# Technical BULLETIN

**RECALL** This modification has top priority. This bulletin must be performed immediately to ensure customer safety.

## 2002~2003 XV17PCP, PCPC, PCR, PCRC FACTORY MODIFICATION CAMPAIGN

## Main Shaft Modification:

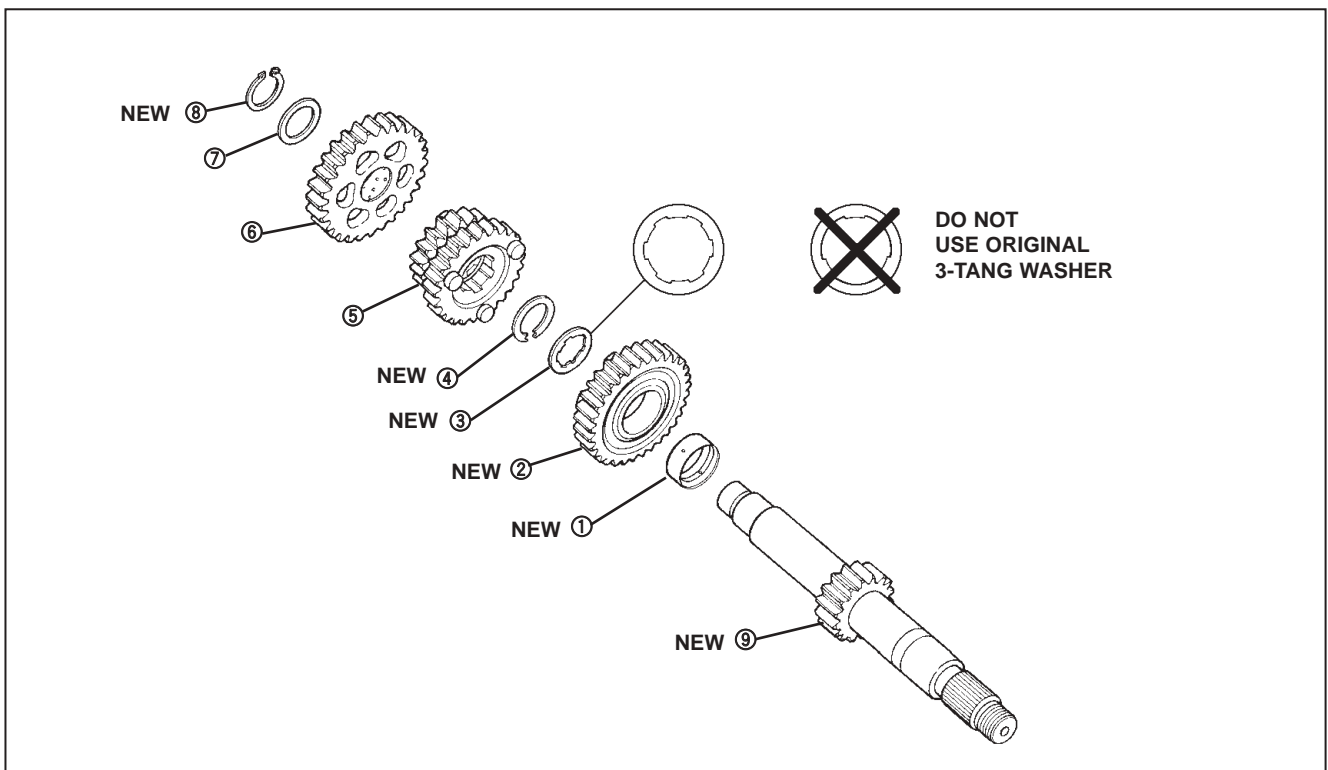
- Completely disassemble the main shaft. The Washer ⑦, 5th Pinion Gear ⑥, and 2nd/3rd Pinion Gear ⑤ will be reused.
- Install the components on the new-type Main Shaft ⑨ in the following order. Lubricate all components with engine oil. Be sure circlips are installed with the sharp edge of the inner diameter facing away from the mating washer.

- ① Collar – NEW
- ② 4th Pinion Gear – NEW
- ③ Washer – NEW
- ④ Circlip – NEW
- ⑤ 2nd/3rd Pinion Gear – Reuse original part
- ⑥ 5th Pinion Gear – Reuse original part
- ⑦ Washer – Reuse original part
- ⑧ Circlip – NEW

Be sure to use all of the new parts in the kit. Otherwise, the transmission can still fail. Be sure that you are installing the new washer ③. It is thicker than the original and can be easily identified by its six tangs on the inner diameter instead of the three on the original washer.

### Drive Shaft Modification:

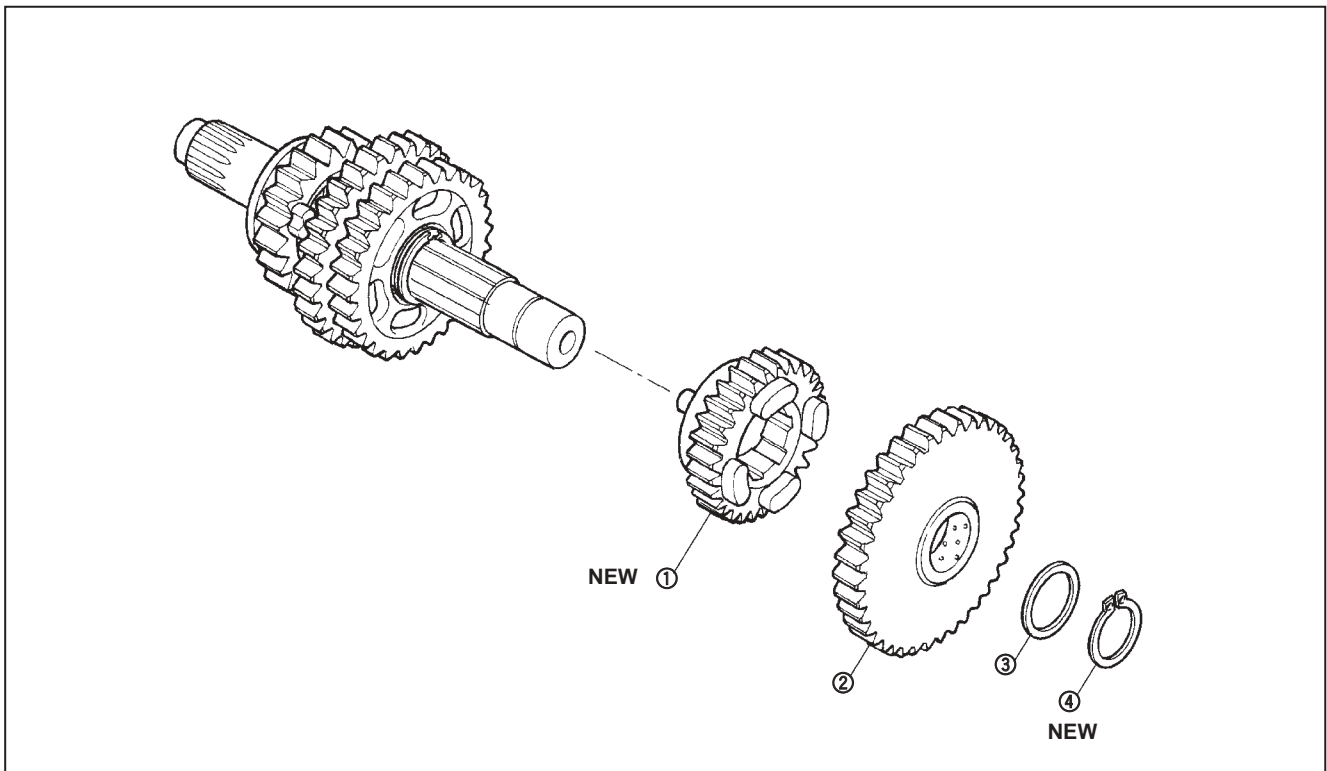
- Remove the circlip and washer from the Drive Shaft, then remove the 1st Wheel Gear and the 4th Wheel Gear. Do not disassemble the rest of the components on the shaft.
- Install the components on the original Drive Shaft in the following order. Lubricate all components with engine oil. Be sure the circlip is installed with the sharp edge of the inner diameter facing away from the mating washer.

- ① 4th Wheel Gear – NEW
- ② 1st Wheel Gear – Reuse original part
- ③ Washer – Reuse original part
- ④ Circlip – NEW

Be sure to use all of the new parts in the kit. Otherwise, the transmission can still fail.

## IDENTIFICATION PROCEDURE

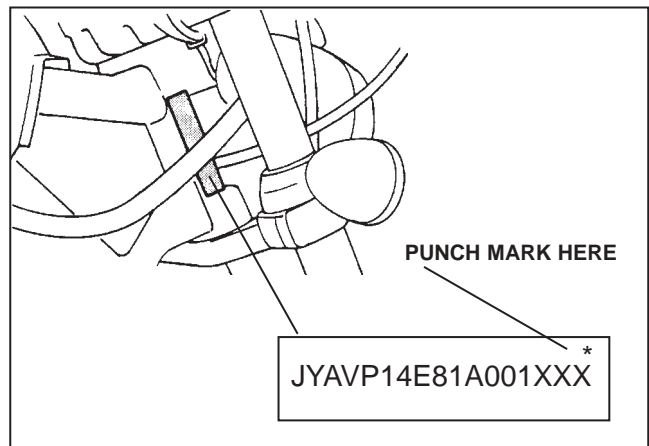
After modifying a unit, make a punch mark above the frame number (VIN) on the steering head pipe as shown in the illustration below.
